DEVELOPMENT REVIEW COMMITTEE (DRC) COMMENT REPORT

PROJECT NAME: Icon 0706

CASE NUMBER: PRE18003

REQUEST: Preliminary Review: Rezoning from Residential Multifamily Mid Rise/ Medium High Density (RMM-25) District to Northwest Regional Activity Center – Mixed Use East (NWRAC-MUe) District to construct 71 Multifamily Residential Units

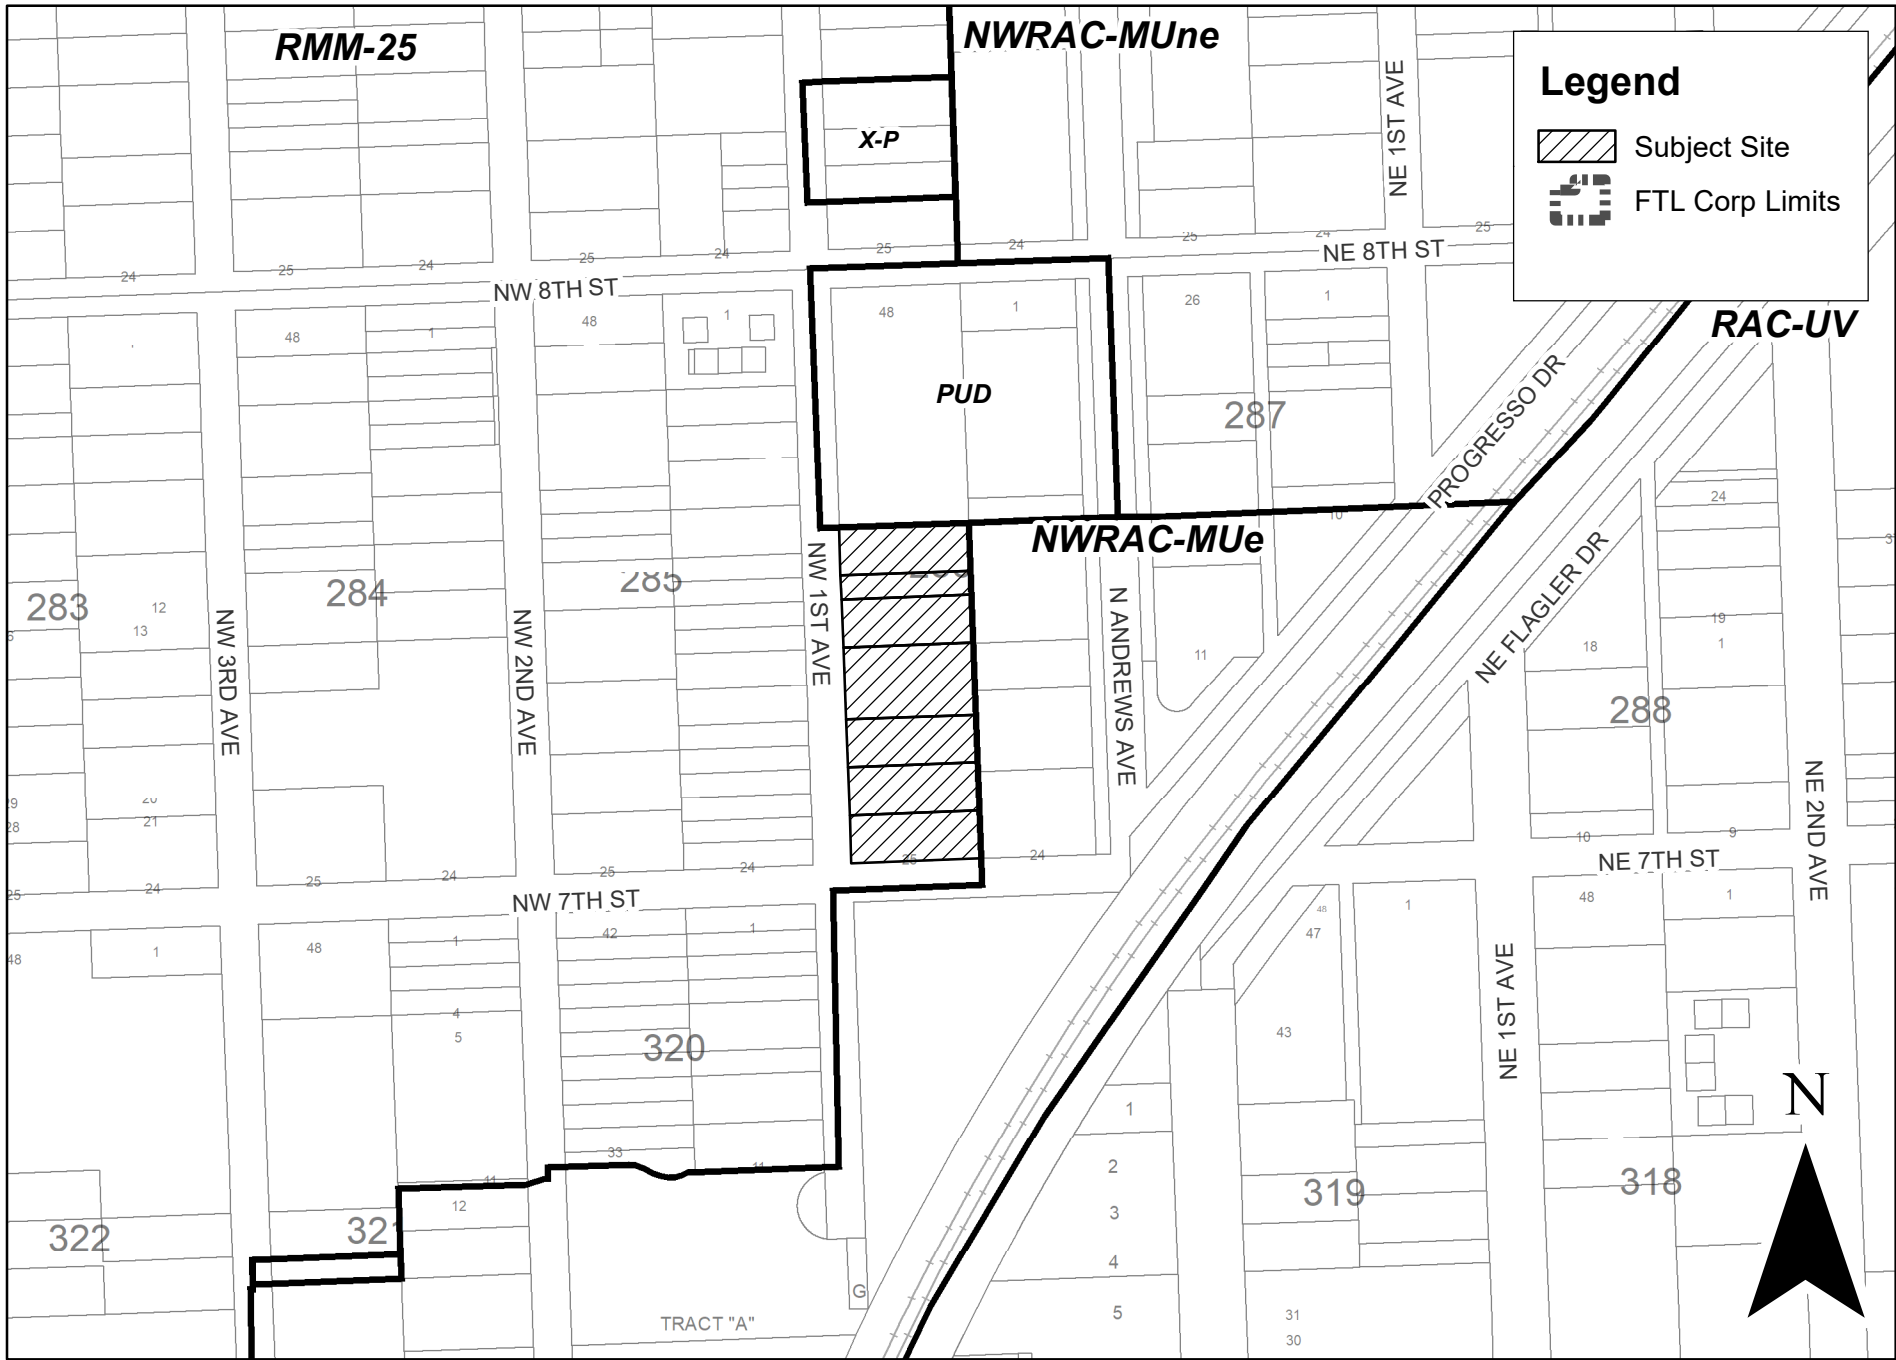
18. NWRAC Design Standard (B-8)- Framing the street: buildings exceeding a maximum streetwall length of 150 ft provide variation in the physical design and articulation of the streetwall

- Although the design of balconies are provided to allow for creative massing. There is an opportunity to minimize the impact of very long building frontages by providing strategic pronounced articulations of the façade and include some architectural design that breaks up the massing of the solid length of the building. The building's massing can be segmented to allow for articulation on all sides of the elevations to complement the lower-height existing building fabric.
